**Application No: 2011SYW127**

**Property: 1444B – 1454 Pacific Highway, Turramurra**

I refer to the above mentioned development application on the agenda of the Sydney West Joint Regional Planning Panel (JRPP) on 6 December 2012. Enclosed with this letter are amended plans prepared to address the reason for refusal with particular reference to building height.

**RE: RESPONSE TO LANDSCAPING REFERRAL CONDITIONS  
1448-1454 PACIFIC HWY, TURRAMURRA NSW**

Arterra Excerpt 28.11.12 1:200 scale at A4

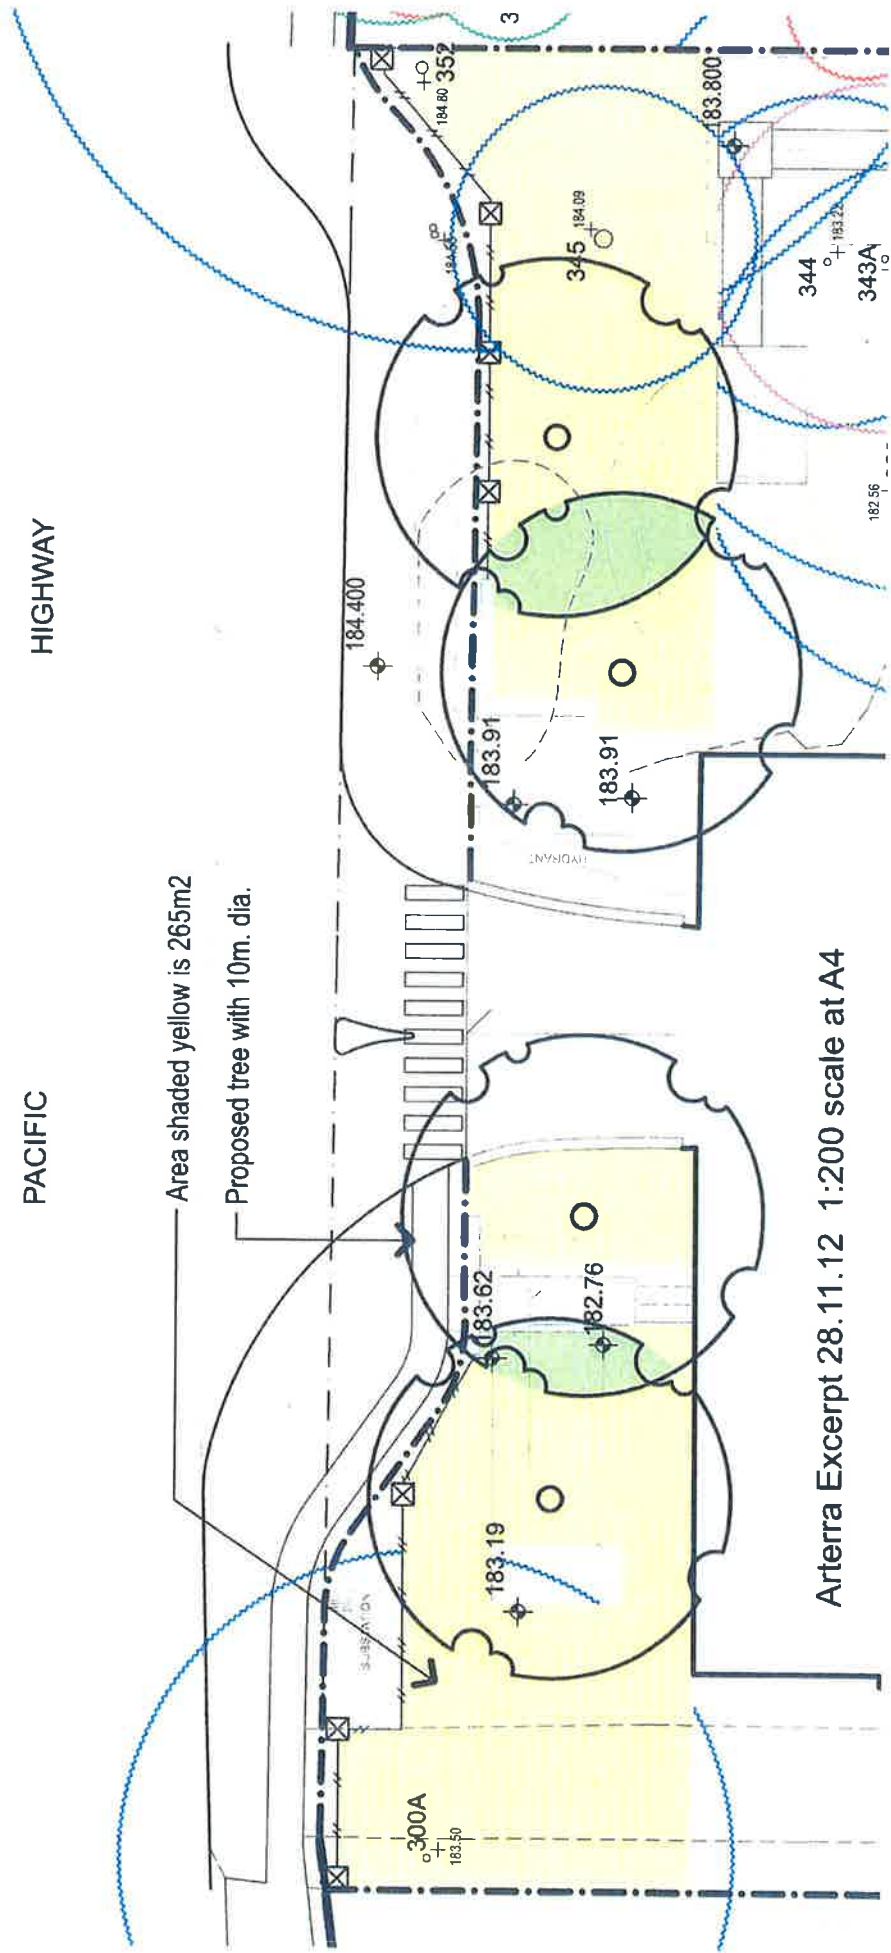
The front boundary has been adjusted to accommodate the deceleration lane. This adjusted boundary is 6m from the building basement not 10 as required in the DCP. Council is arguing that there is insufficient deep soil in the setback area to support suitable trees to soften the appearance of the development.

By reducing some of the paths in the front setback zone from 1.2m to 1m. (which is acceptable under the accessibility standard AS1428) we can demonstrate that there is 265m<sup>2</sup> of deep soil available as defined by the DCP. Refer diagram attached 28.11.12. Assuming a soil depth of 750mm there is 198m<sup>3</sup> of soil available for tree planting.

They propose that a mature tree requires 0.6m<sup>3</sup> of soil for every 1m<sup>2</sup> of canopy area. E.g. a tree with a 10m. dia has a canopy area of 78.5m<sup>2</sup> and requires 47m<sup>3</sup> of soil. With 198m<sup>3</sup> available we propose that four large trees could be sustained within the front set back area.

The attached diagram illustrates the effect of four 10m dia trees in the front setback zone.
